**rotork**

April 6, 1984

Subject: Rotork 14NAT1 Torque Limiter Failure - 10CFR21 Report

FIGURE 1

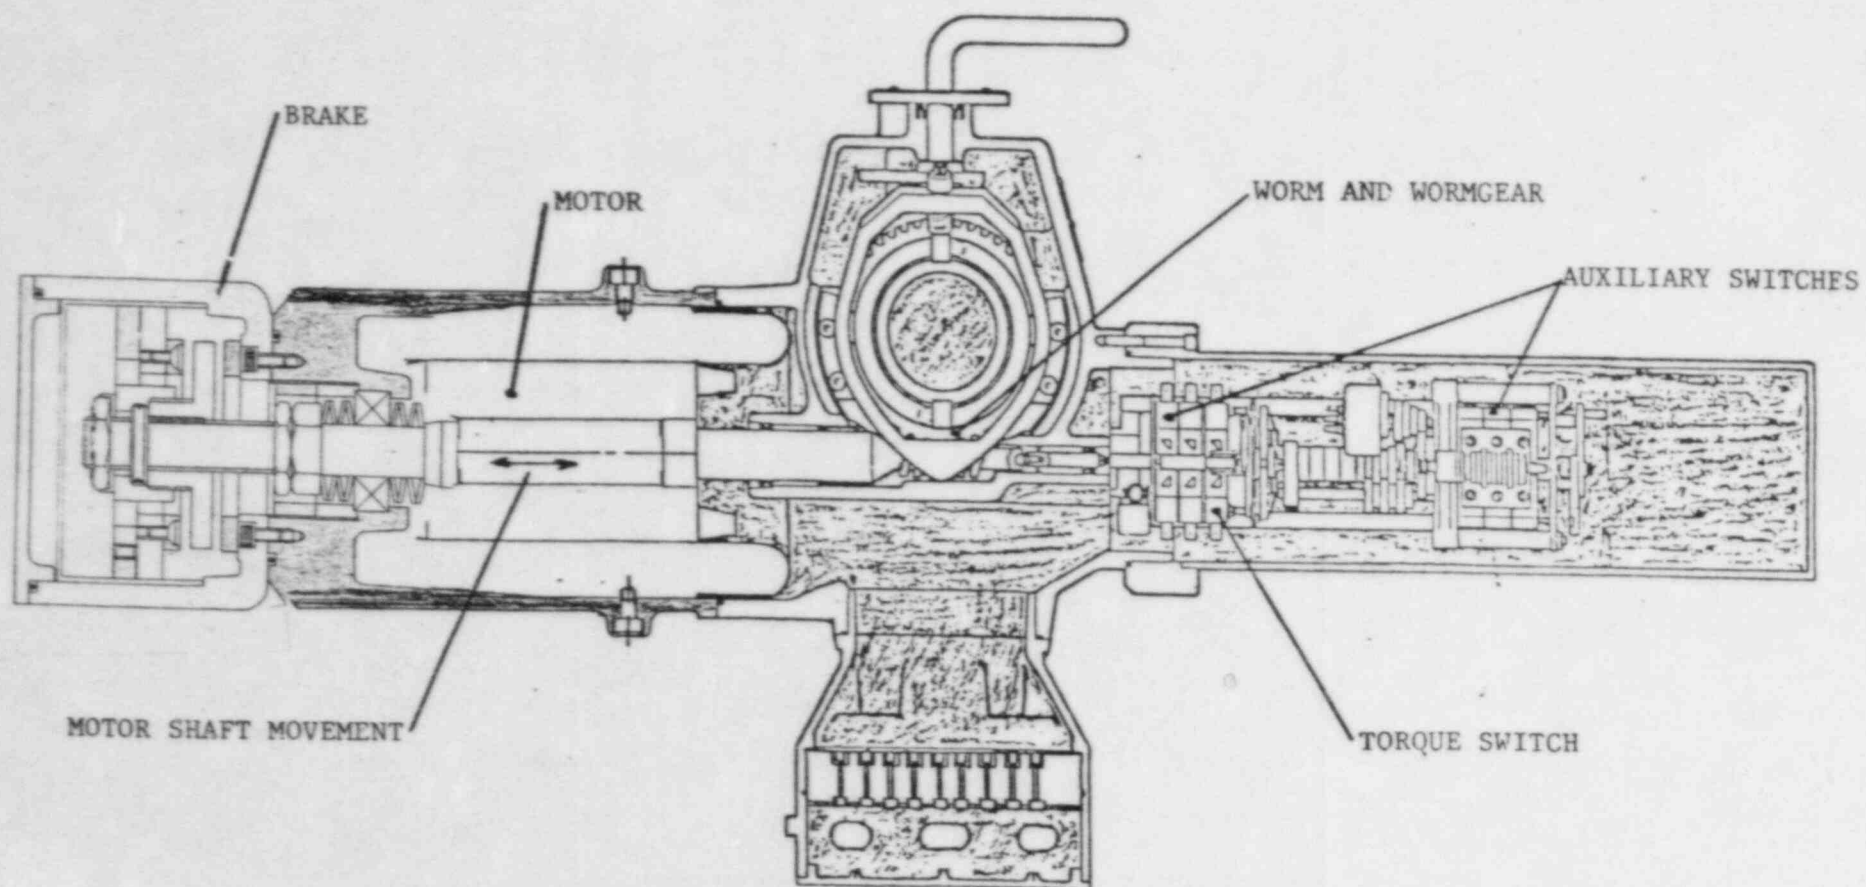
The problem occurred because of high speed operation on particular valve assemblies. Rotork's torque limiter design (see Section 9.2 attached and Figure 1) is an optional feature of our standard nuclear actuators. The torque limiter provides a means of guaranteeing and limiting final torque from the actuator under stall conditions.

Testing at Catawba has shown that although the close torque switch tripped, the inertia and contactor dropout delay time was sufficient that the brake disc (Item 1) did contact the close side brake pad (Item 3). During subsequent operation in the open direction, the brake disc would contact the open side brake pad (Item 2). Unfortunately, the torque on the locking set screw (Item 6) was incorrect. The open side thrust pad (item 4) is held in position by the locking ring (Item 7) exerting force through the set screws (Item 6). The outside of the locking ring and the thrust pad are threaded to the brake housing (Item 5).

Note that the threading on the housing is left handed. With low torque values on the set screws, the open side brake position tended to move towards the disc. Eventually, the brake disc hit the brake pad during normal operation and caused several motors to burn out.

Testing in our facility has shown that we have been putting approximately 15 inch pounds of torque on the 10-24 set screws (Item 6). The correct torque for these set screws is 33 inch pounds. After placing 33 inch pounds of torque on the set screws, the actuator torque limiter worked properly. To avoid a design which is sensitive to the torque placed on these set screws, we have changed to 5/16 UNF set screws with a torque of 12 - 13 foot pounds. Tests on the design with 5/16 UNF set screws have shown that the actuator will function properly throughout its life.

All 14, 16 and 30NAT1 actuators with 173 RPM (all located at Catawba) will have the open locking ring (Item 7) replaced. The new locking ring will have 5/16 UNF set screws. A procedure has been developed to enable field replacement of these locking rings.
